Access Compliance Report

Public Rights-of-Way

(Curb Ramps)

Intersection ID: 10090	Main Street: ROSLYN_AV	Cross Street: S_TURNER_AV	Location: W
ADA ID: 34075E7EF65E	Ramp Type: PerpDiag	Initial Pass/Fail: Fail	Overall Compliance: No
		Severity Score: 10

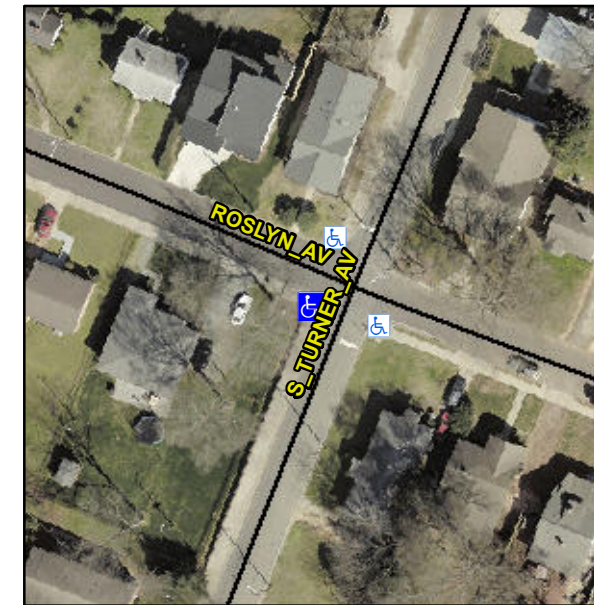
Not Found, R304.5.1, R304.5.3

Compliance	Description	Data	Compliance	Description	Data
N/A	Ramp Length (in)	73.0	Yes	Ramp Slope (%)	5.2
No	Ramp Width (in)	47.5	No	Ramp XSlope (%)	2.1
N/A	Flare Type LT	N/A	N/A	Flare Type RT	N/A
N/A	Flare Slope LT (%)	N/A	N/A	Flare Slope RT (%)	N/A
N/A	Flare Traversable LT?	N/A	N/A	Flare Traversable RT?	N/A
N/A	Landing Length (in)	N/A	N/A	DWS Provided?	N/A
N/A	Landing Width (in)	N/A	N/A	DWS Contrast?	N/A
N/A	Landing Slope (%)	N/A	N/A	DWS Length (in)	N/A
N/A	Landing X Slope (%)	N/A	N/A	DWS Full Width?	N/A
N/A	Landing Curb? (Y/N)	N/A	N/A	DWS Offset (in)	N/A
N/A	Shared Landing?	N/A			
N/A	Gutter Ponding?	N/A	N/A	Gutter Slope (%)	N/A
N/A	Gutter Lip Ht (in)	N/A	N/A	Gutter X Slope (%)	N/A
N/A	Painted X Walk1?	No	N/A	Painted X Walk2?	No
	X Walk 1 Direction	To SE		X Walk 2 Direction	To NE
N/A	X Walk 1 Width (in)	N/A	N/A	X Walk 2 Width (in)	N/A
	X Walk 1 Slope (%)	6.5		X Walk 2 Slope (%)	2.0
	X Walk 1 X Slope (%)	1.4		X Walk 2 X Slope (%)	2.0

Remove & Replace Curb Ramp With Two New Directional Ramps or Equivalent.
